Safety Advisory #1 – Wheel Plate Bolts

Rev. 1B, Oct. 8, 2016

Affected Models:	All Models, all Serial Numbers
Issue:	Main Landing Gear Failure to Extend
COG Recommendation:	Ensure that your aircraft has the correct wheel Plate hardware and that it is installed correctly as per the IPC. In addition, inspect your rubber stop bumpers for condition.
Purpose:	Eliminate a binding condition that can cause the main gear assembly to hang up and not extend

S <input checked="" type="checkbox"/> P <input type="checkbox"/> M <input type="checkbox"/> E <input type="checkbox"/>
DRAWING NUMBER
42308
DRAWING TITLE
BUMPER ASSY-UP STOP, MLG

Figure 1

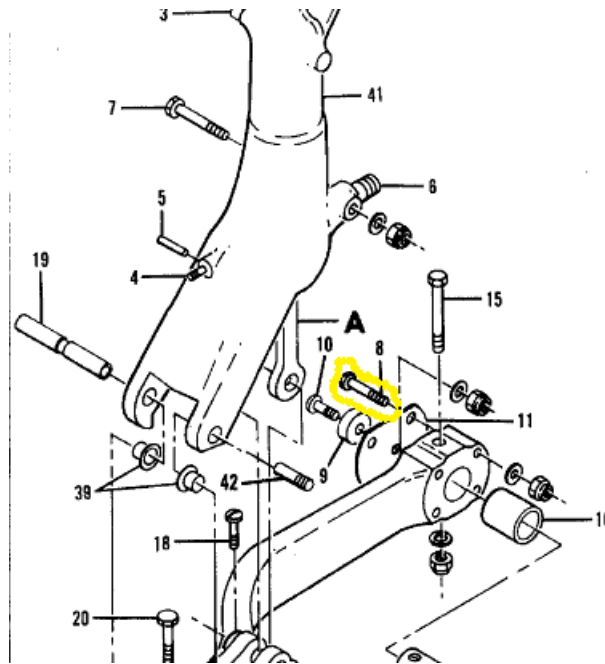
Recently we had an owner experience a main landing gear that failed to extend (downward) as a result of being hung up in the wheel well. The primary cause was determined to be a bolt on the lower landing gear yoke assembly which holds the *Plate* (**Figure 1**; 112/114 IPC 2-15-8, AN5-24A) having been installed backward and the exposed threads then becoming caught on the edge of the Up-Stop Bracket when the gear is in a raised position. (**Figure 2**; *Bracket, MLG Up-Stop pn 42385-3*. **Note: 42385-3 is not shown in 112IPC**)

It is **highly recommended** that as soon as practical, you inspect your main landing gear to insure that the correct length bolts are properly installed with the bolt heads on the same side as the rubber bumper. **Any deviation from the IPC parts specifications and position guidance should be corrected immediately.**

Figure 2

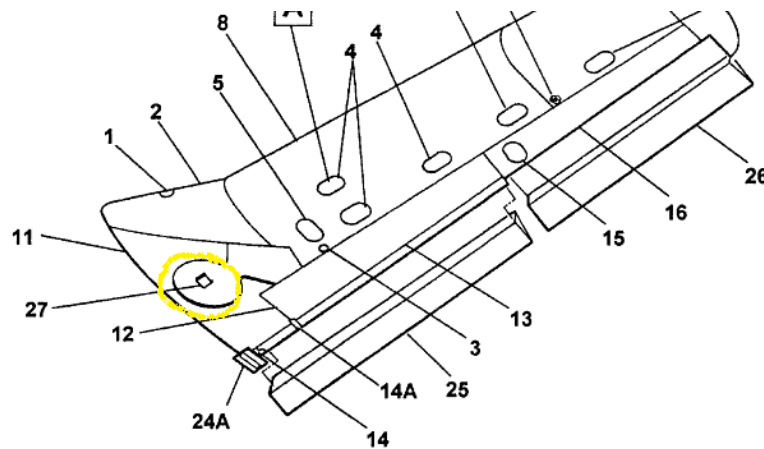
1. Bumper that was worn out and compressed
2. Bolts on the Main Landing gear Yoke assembly fastening the *Plate* (2-15-11, pn 42308-3) being installed in a reversed condition. (Yoke is Item #22 Figure 2-15 in Commander IPC)
3. Incorrect longer bolts installed. (Bolts are Item #8 Figure 2-15 and item #14 or 27, Figure 2-16)
 - a. **Note: the nut specified on the AN5-24A bolt is a thin profile MS20364-524 nut**
4. The *Bracket, MLG Up-Stop* that the bumper contacts in the wheel well has been found to be in slightly different wheel well locations on each plane due to the hand assembly of each wing structure. See *Figure 2*.

SECTION A-A

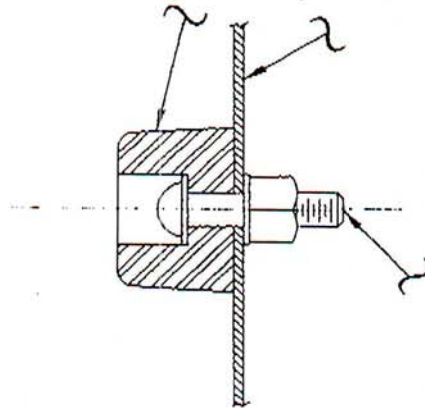
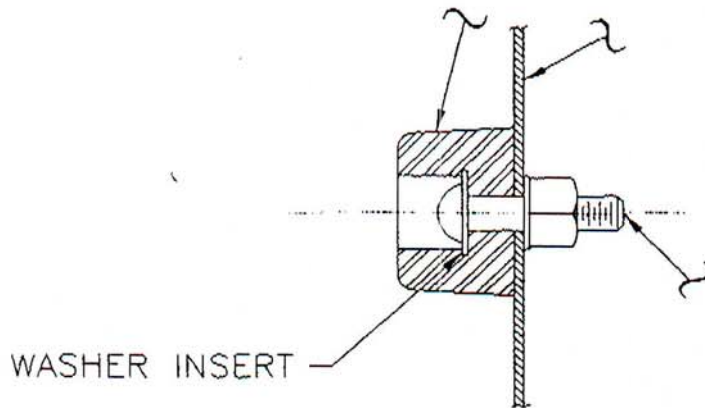
3. CHG SEC A-A, WAS:

REQ'D:

SECTION A-A

(-1 ONLY)

SECTION A-A
 (-501 ONLY)

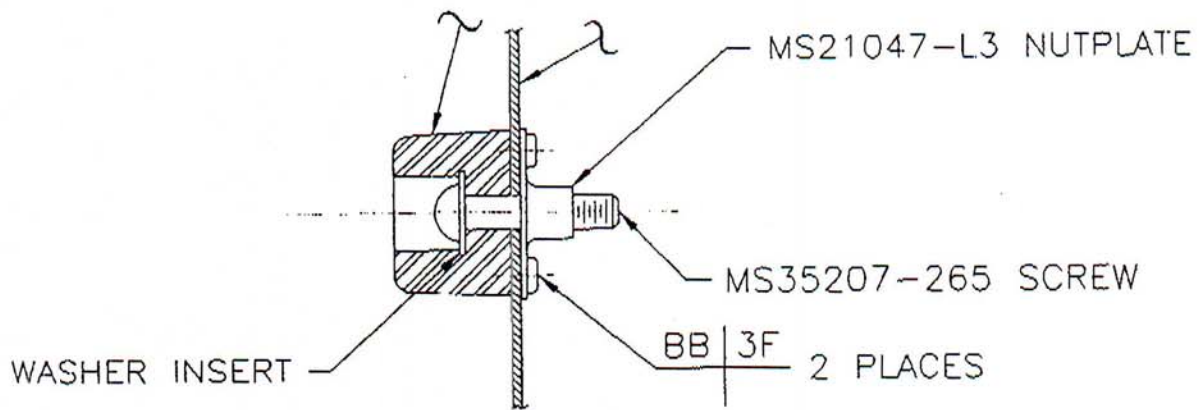
4. ADD SECOND SEC A-A, S/A SEC A-A EXCEPT AS SHOWN:

2. CREATE -501 S/A -1 EXCEPT AS SHOWN, & ADD TO PL:

-501	-1	PART NO.	NAME
1		MS21047-L3	NUTPLATE
	1	AN365-1032	NUT
1	1	MS35207-265	SCREW
	1	AN960-10L	WASHER
